**\*\*\* IMPORTANT SAFETY RECALL \*\*\***  
**NHTSA Recall No. 20E-018**  
**Cummins Campaign #C2302**

Cummins Inc. has decided that a defect which relates to motor vehicle safety exists in certain B6.7 diesel engines that were manufactured between December 16, 2015 and March 24, 2020 and equipped with fuel module option FS90301 or FS90453.

Cummins has released field Safety Campaign #C2302 "B6.7 Engine-Mounted Fuel Heater Safety Campaign" to correct this condition. This campaign is currently available at Cummins

Figure 1 - Location of Fuse on Navistar® CE Bus and 1300 FBC.

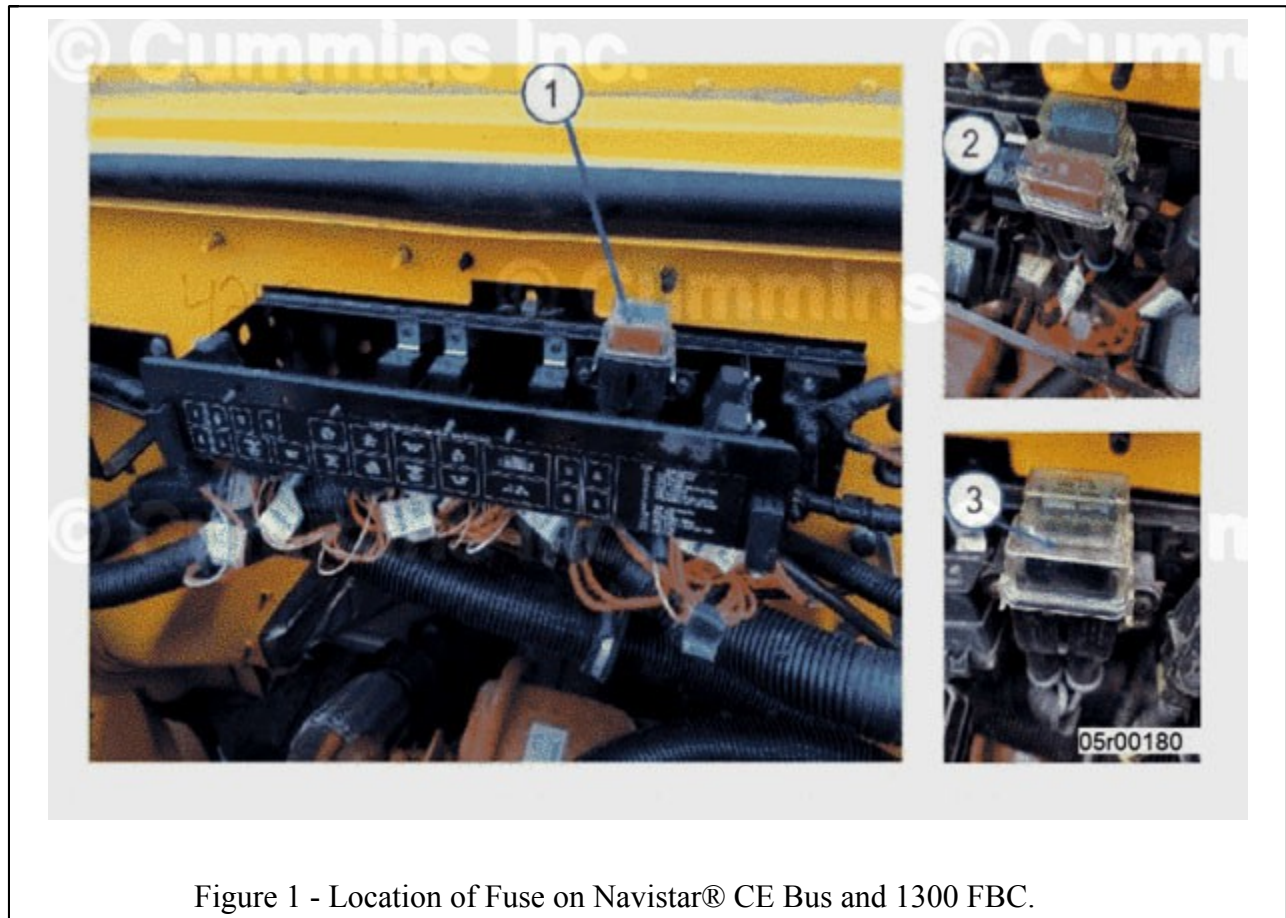
**Navistar® CE Bus and 1300 FBC Fuse Removal Instructions (Reference Figure 1 below)**

1. Disconnect vehicle battery.
2. Locate red 50 Amp or green 30 Amp Maxi Fuse on under hood fuse panel.
3. Remove fuse cap and discard red or green Maxi Fuse.
4. Reinstall fuse cap. Do **not** replace fuse.
5. Reconnect vehicle battery.

Figure 2 - Location of 30A or 40A Fuse on Navistar® MV/HV/TC.

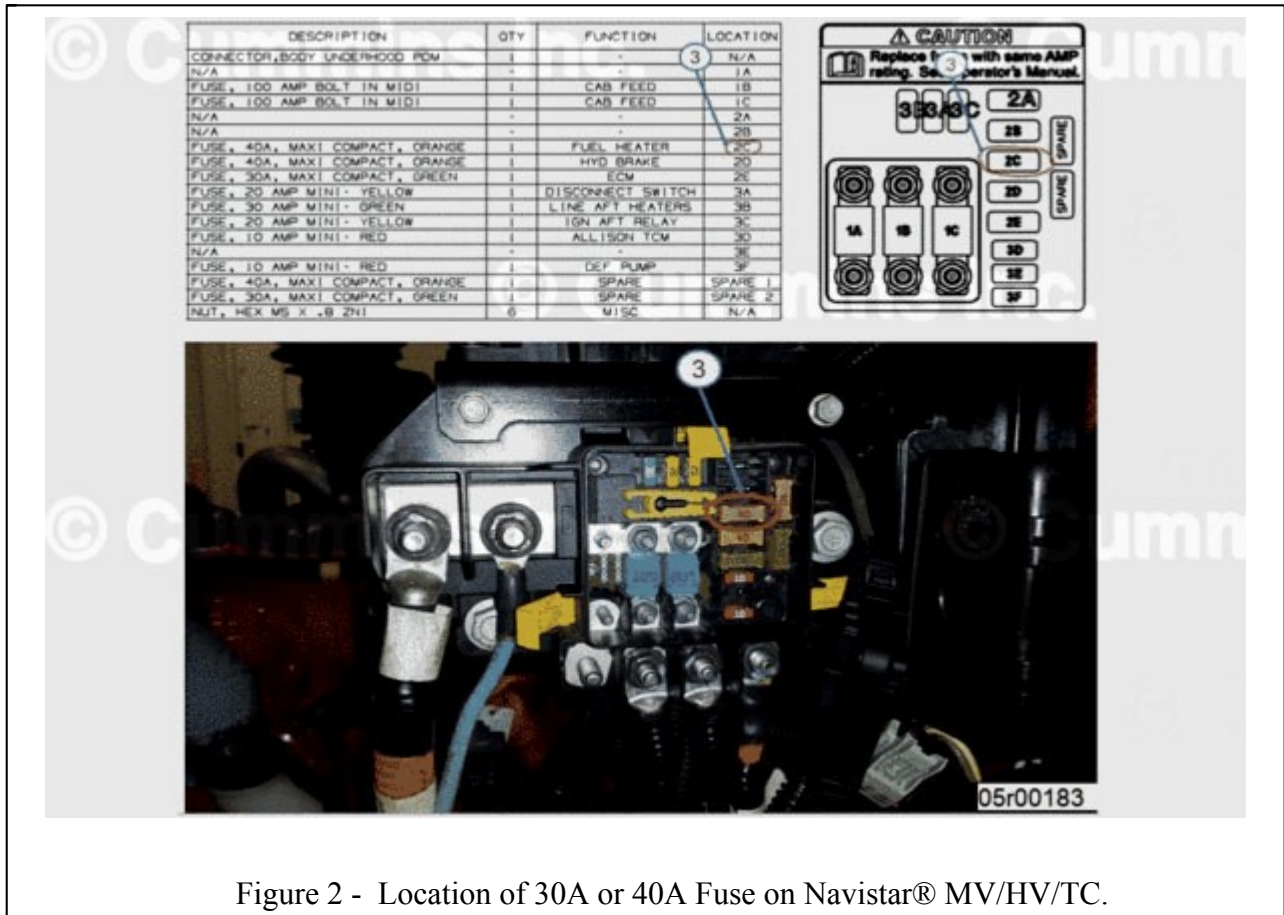
**Navistar® MV, HV and TC Commercial Bus (some DuraStar (4300)/WorkStar (7300)  
Fuse Removal Instructions (Reference Figure 2 below)**

1. Disconnect vehicle battery.
2. Remove 30 or 40 amp fuse located at 2C cavity.
3. Reconnect vehicle battery.
